PR #: Nine -REVISED (9R)

TO: David Beiersdorfer Jr.
Endeavor Construction
977 State Route 28
Milford, Ohio 45150RE: Gallatin Co. Alternative School & Field House
Gallatin County, Kentucky
BG 12-133
RTA 0914

DESCRIPTION: Install a French Drain and sidewalk from the Alt. School/Field House to the new football grandstands.

PR9.R DATE ISSUED: 01/12/08	BG#12-133	PROPOSAL REQUEST NO. 9R GALLATIN COUNTY ALT. SCHOOL & FIELD HOUSE FOR THE GALLATIN COUNTY BOARD OF EDUCATION	 rosstarrant architects 101 old lafayette avenue lexington, kentucky 40502 p 859.254.4018 f 859.231.5046

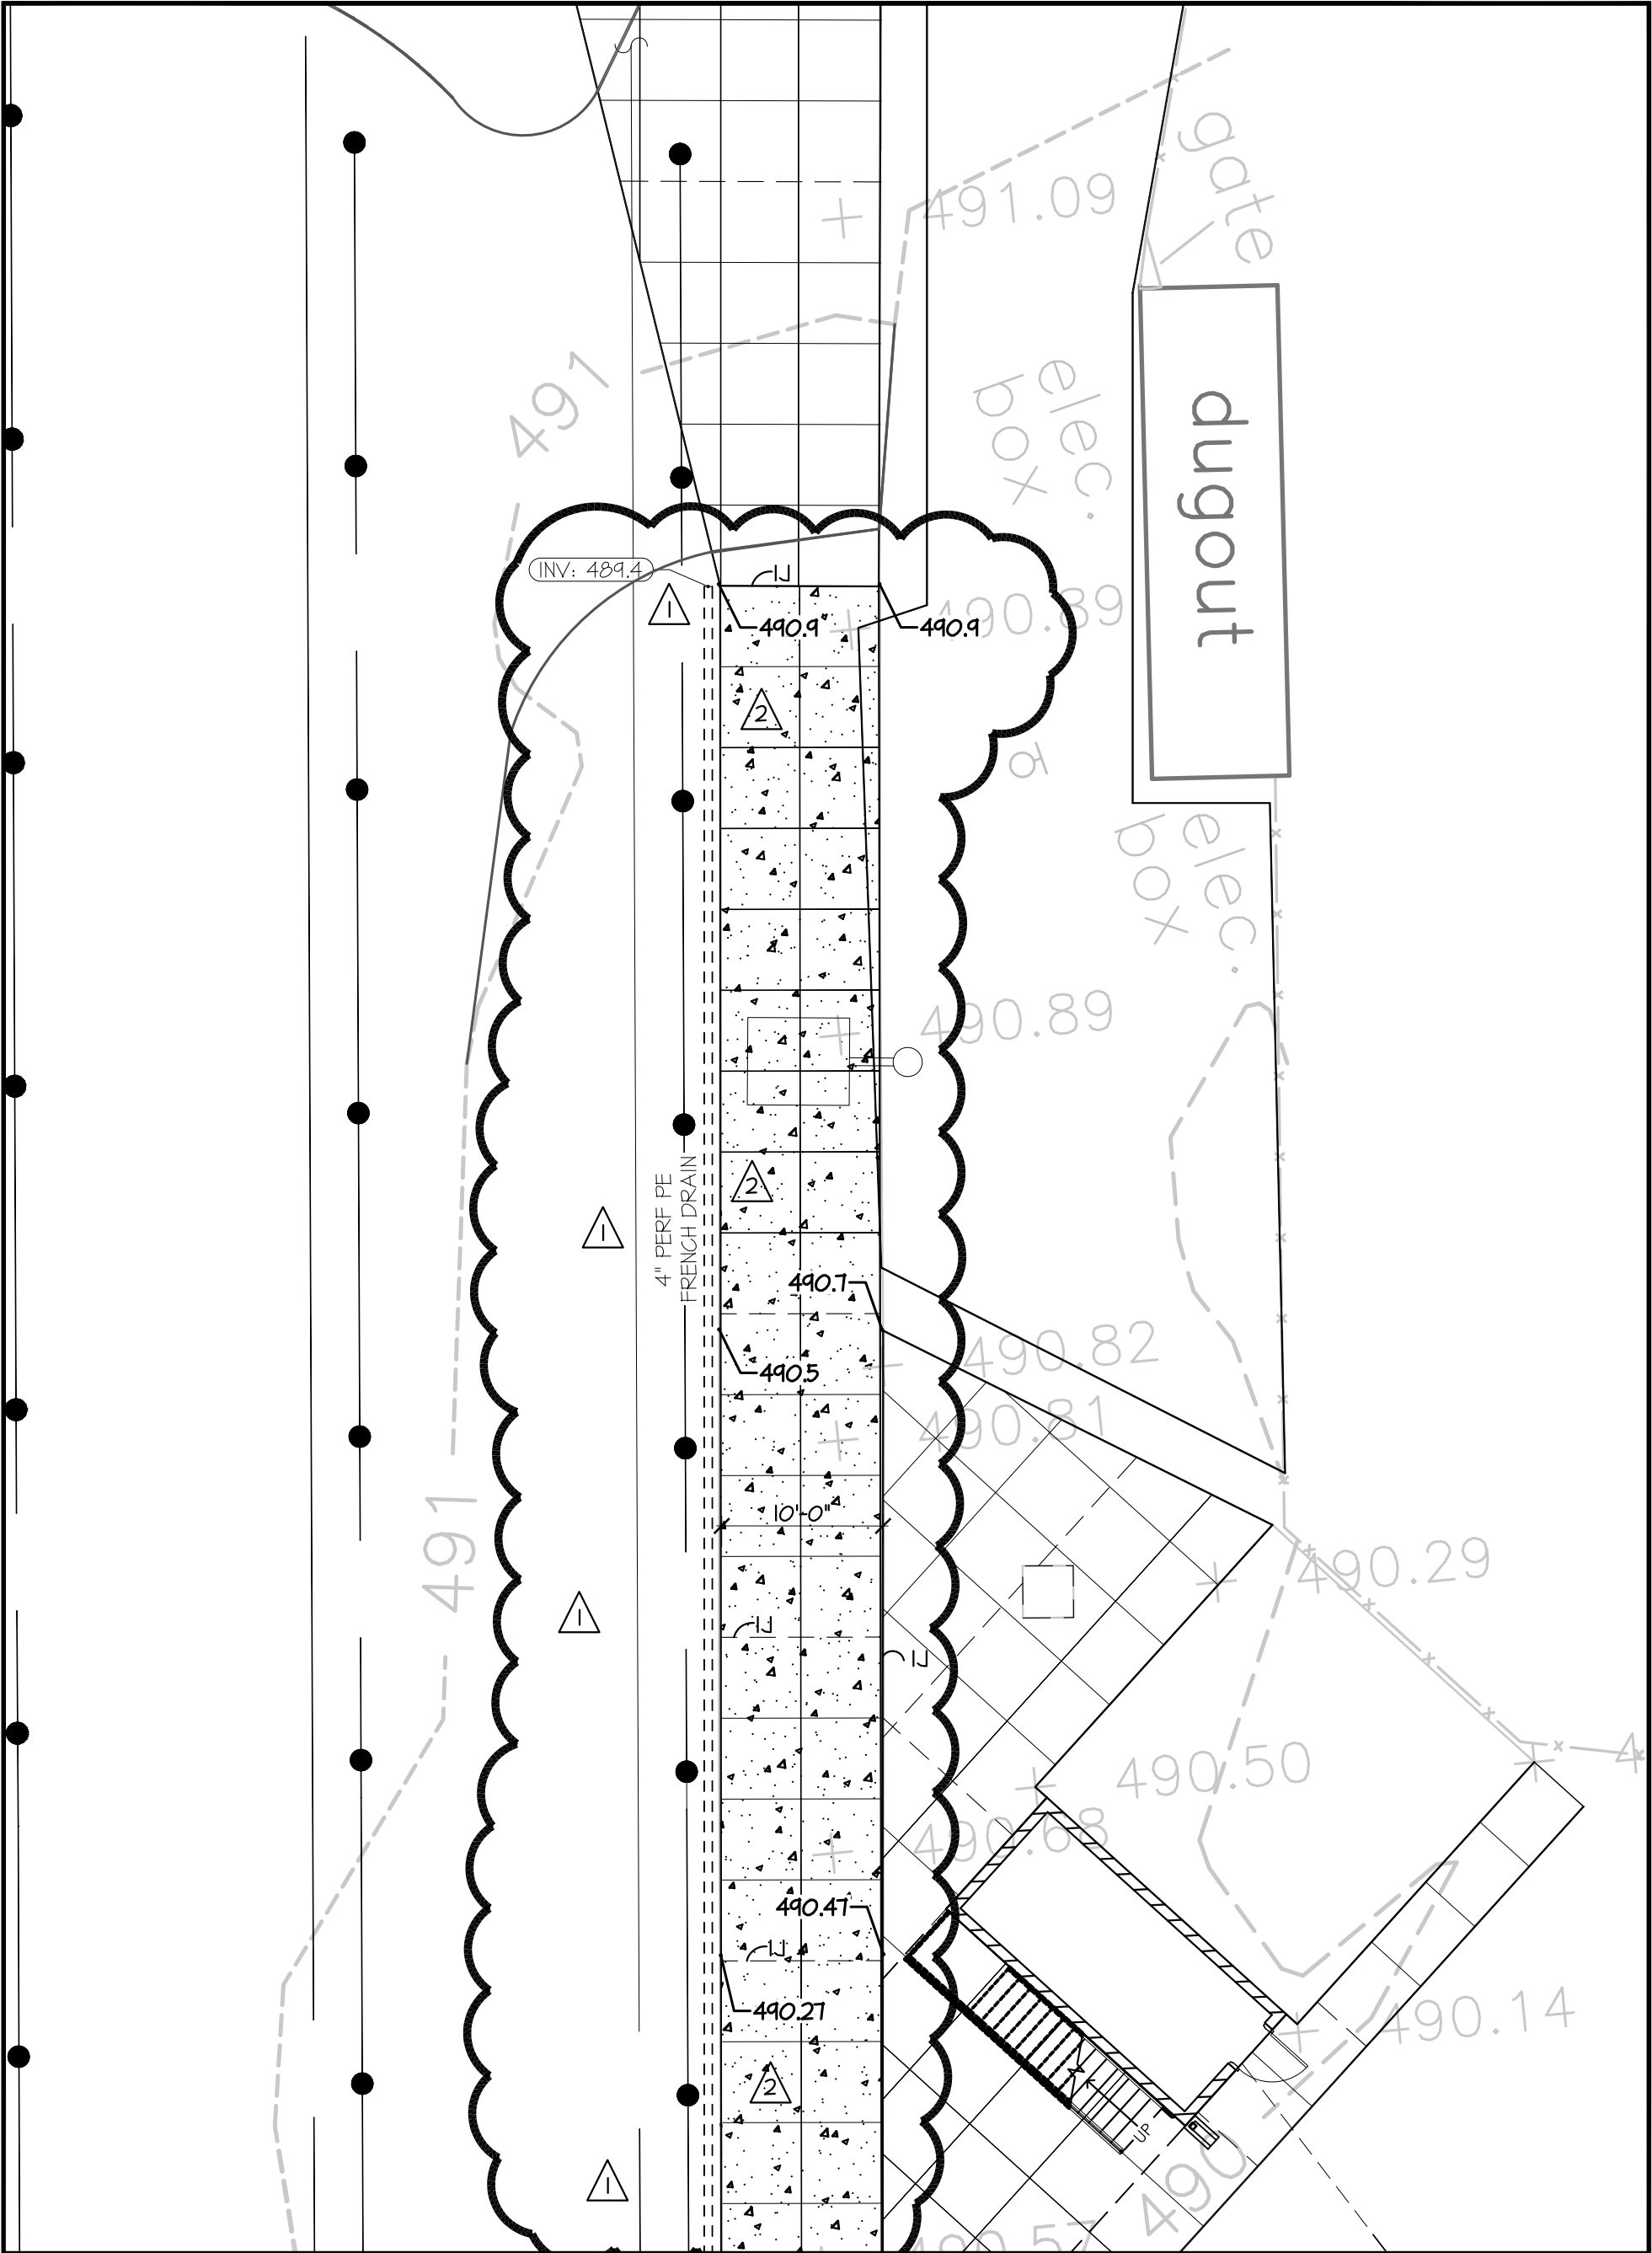
Refer to sheet SD2.1, Site Drainage Plan, SD3.2 and SD3.3 Enlarged Site Plans. Provide grading, French drain installation, removal of existing sidewalk, and installation of new sidewalk as indicated on the attached sketches. Contractor is to provide price breakdown for labor and materials required.

- 1 INSTALL FRENCH DRAIN. SEE DETAIL H/SD4.1.
- 2 REMOVE EXISTING SIDEWALK AND REPLACE WITH 6" DEPTH SIDEWALK. SEE DETAIL H/SD4.1.
